### **FPL responses to questions raised by ENP in letter of August 10, 2009**

Thank you for your response letter dated September 4, 2009. The information you provided was helpful, but we find that we have questions about the information you provided. Furthermore, we have additional questions that are critical to our understanding of your proposal and that have an important relationship to the National Environmental Policy Act (NEPA) analysis that the National Park Service (NPS) is required to complete for the proposed action.

**Subject: Response to October 2, 2009 Correspondence Regarding ENP-FPL Land Exchange (L1417)**

## CONCEPTUAL PLAN VIEW WITH UNDERLYING OWNERSHIPS

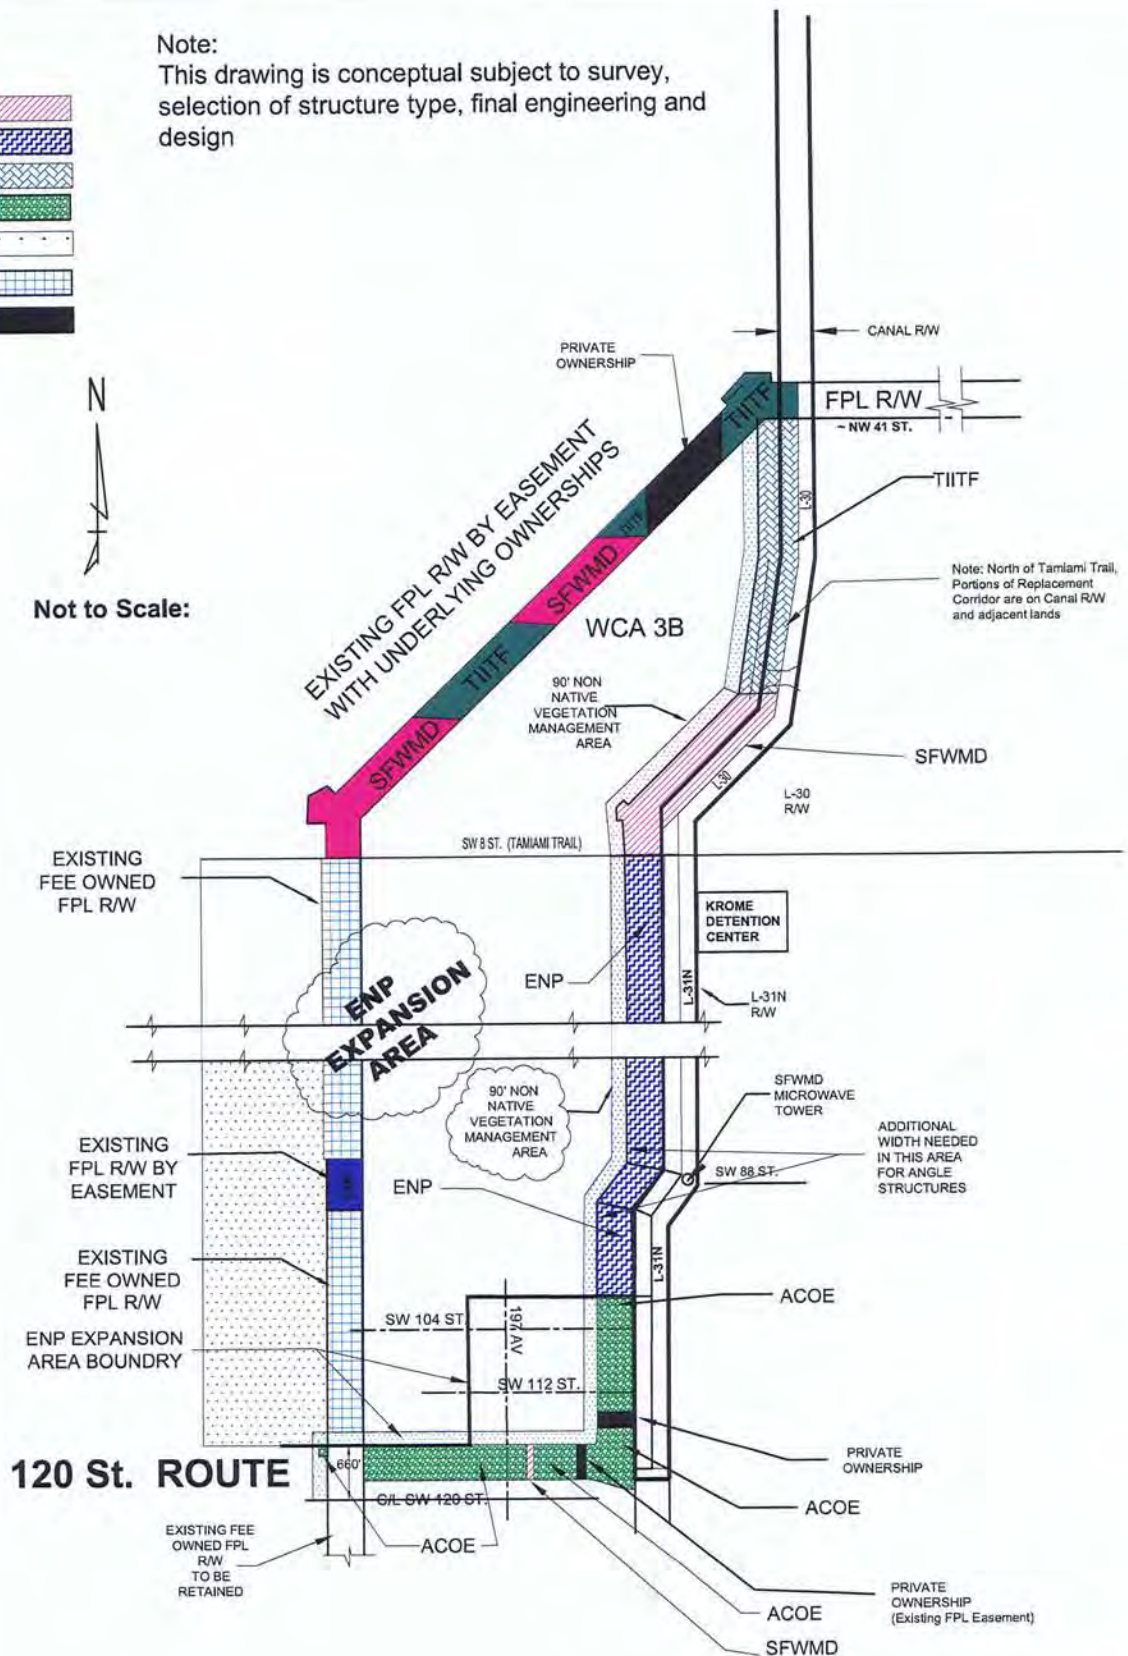
**4. Please provide the most recent detailed drawings, site plans and description of the overhead transmission infrastructure that would be constructed on the exchange lands, the methods of construction and requirements for operation and maintenance.**

Nonetheless, and for information purposes and to facilitate completion of the EA, FPL is providing the following regarding the development of transmission lines in the proposed corridors.

While applications for certification of a transmission corridor have been filed, no specific construction project has been approved. Design details are not finalized until after the corridors are certified. However, the site certification application filed with the FDEP under the PPSA contains typical drawings and cross sections for the corridors. Please refer to Section 9 West of FPL's Turkey Point Units 6 & 7 Site Certification Application (SCA) for descriptions of the construction, operation and maintenance methods as well as figures depicting typical structures, ROW cross sections, and road and pad design. A CD of Chapter 9 of this SCA which address the proposed transmission lines is enclosed for your convenience. The facilities and their construction operation and maintenance would be similar for any ROW location, adjusted as necessary to address site specific factors.

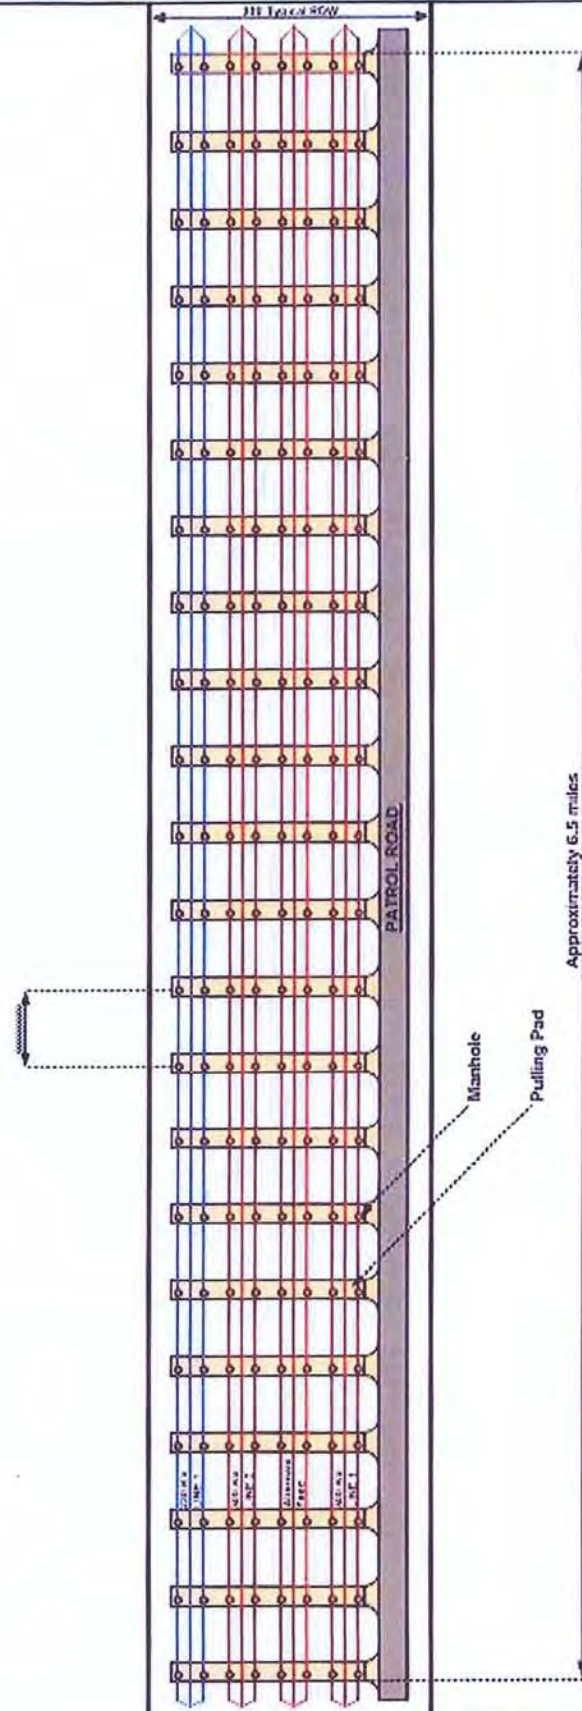
**8. Page 5, 1<sup>st</sup> paragraph: FPL states that "the width of the required underground rights-of-way for an underground option would be significant...". Does this mean that a 300' right of way would be sufficient or insufficient? Please explain.**

The underground facilities addressed above (two 500 kV lines) could be accommodated within the 330 ft right-of-way, although the direct environmental impacts would be greater than an overhead line. However, as noted in the response to Question 5 above, additional land rights likely would be required for autotransformer stations at each end of the underground section.

NPS clarified that it was also their intent to place the Clear Sky-Pennsuco 230 kV line underground in this area. A specific design has not been prepared for such a 230 kV line and FPL does not have an underground 230 kV line of similar capacity. However, it is anticipated that the 330 ft right-of-way would be adequate to include this line as well.

# EVERGLADES NATIONAL PARK 6.5 MILE UNDERGROUND CONCEPT CONCEPTUAL PLAN VIEW

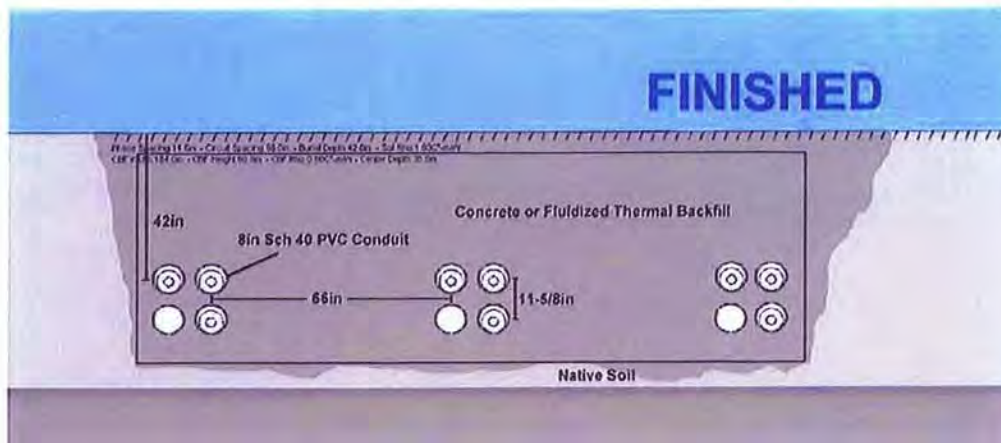
**9. Page 5, Trench Details graphic: Please include dimensions in these cross-sections.**

Each ductbank would have a minimum separation of 5.5 ft in a trench approximately 20 ft wide. Adjacent trenches would be separated by at least 25-30 feet to minimize mutual heating and provide some isolation from each other. A 230 kV ductbank system has not been designed but would require similar separation from adjacent circuits. A conceptual plan view of a duct bank system including two 500 kV circuits, one 500 kV alternate feed and one 230 kV circuit is provided below and illustrates the features of such a system and the location of resultant surface impacts.
